REVISIONS TO CONSERVATION GUIDELINES

Fig. 2.1: Allowable form of new rear extension in Residential Historic Districts.

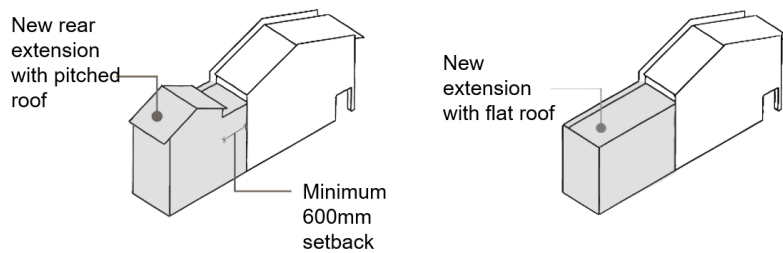
In the Residential Historic Districts such as Emerald Hill, Cairnhill and Blair Plain, a new extension can generally be added at the rear of the main conserved building to provide more living space. The form and height of the new rear extension is guided

to maintain the scale and character of the historic roofscape. [Fig 2.1] Design and material of the rear extension's façade can vary.

Fig. 2.2: Non-traditional roof forms which will not be allowed.

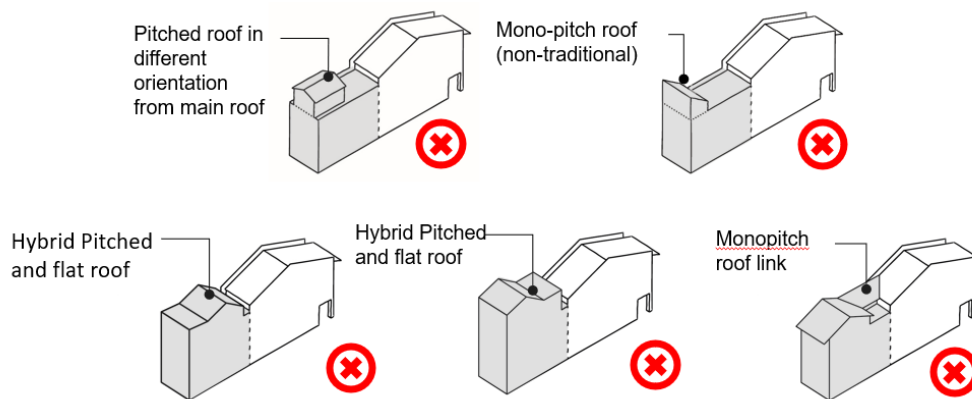
Additional diagrams on new rear extensions have been made to provide further clarity on what constitutes non-traditional roof forms that are not supported. [Fig 2.2]

For units with rear extensions in highly prominent locations, e.g. where side and rear elevations face main roads, key vistas and public spaces, the design will be guided more closely so that the architecture as well as the overall scale, urban grain and relationship to the historic buildings are sensitive. The buildings are as indicated on [URA Space](#). Any submission of planning applications involving a rear extension to these units shall be accompanied by a Design Statement of Intent (DSI). A template of the DSI can be found in [Appendix 2](#).

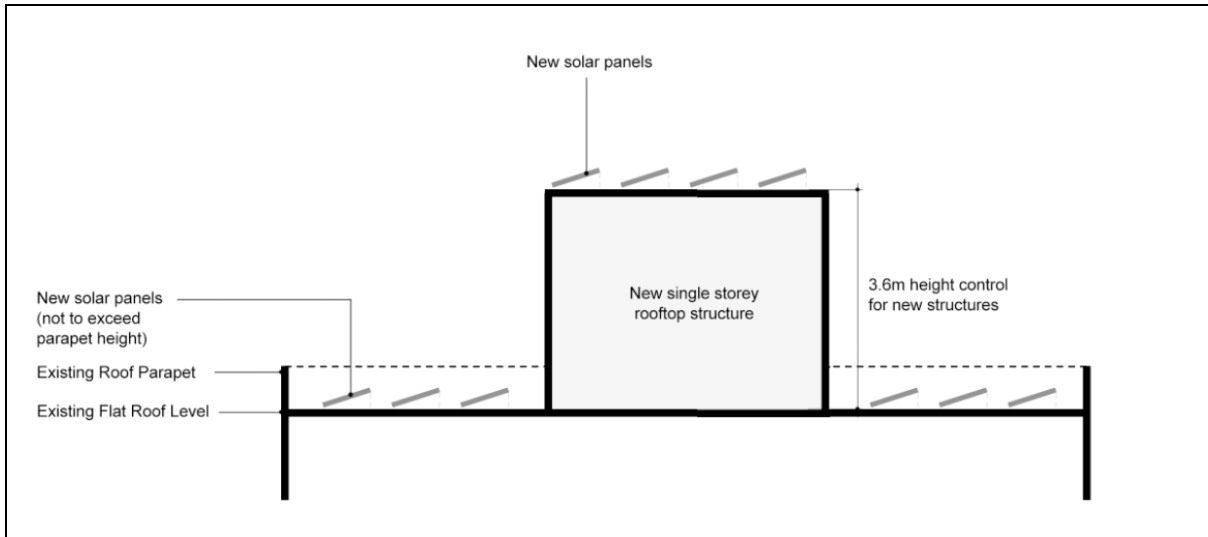
For conserved shophouses with pitched roofs, solar panels can be added following guidelines for skylights, i.e. not exceeding 30% coverage of the rear slope of the main pitched roof or any slope of the secondary pitched roof.

A section on solar panels has been added for clarity on addition of solar panels to conserved shophouses. For conserved shophouses with pitched roofs, the existing guideline remains, as above.

To support the move towards sustainable buildings, greater flexibility can be considered for addition of solar panels on conserved buildings with flat roofs:

- a. Solar panels installed on existing flat roofs will be excluded from coverage control of new structures added on existing flat roofs. Such panels can be elevated to not exceeding the existing roof parapet height.
- b. Solar panels can also be installed on top of new structures added on existing flat roofs and concession can be given for the installations to exceed the 3.6m height control for new structures.
